Flood Impact and Risk Assessment

6-8 Julius Avenue North Ryde

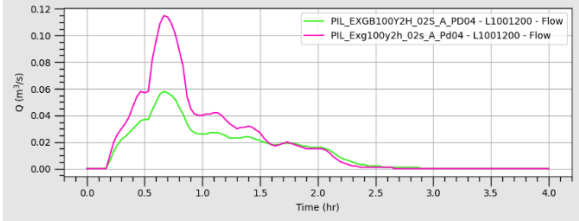
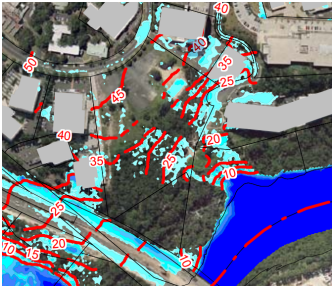
NSW Department Assessment team comments:
